Re: **Consultation on an Application**

Planning Application Ref: PL/25/1272

Address: West Chazey, Upper Warren Avenue, Caversham, Reading, RG4 7ED

Proposal: Proposed new pool house

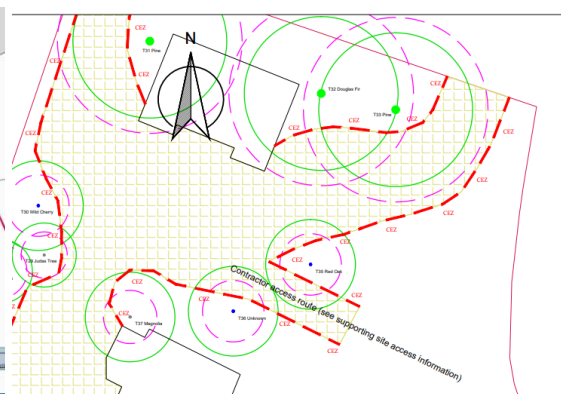
I am unclear why the trees/vegetation which are adjacent to access route have not been surveyed, considered and protected. With reference to the Proposed Site Plan, 9th July 2025, Drawing No.02, Rev A, the access route is clearly shown and thus it is expected that the trees/vegetation are plotted, considered and protected here.

I also note the material storage is located within an RPA of a protected 'A' category tree, seemingly in the same location as the tree (T32) which isn't acceptable or feasible, and material storage should be outside RPAs and certainly outside the tree protection zone (with suitable ground protection if within RPAs):
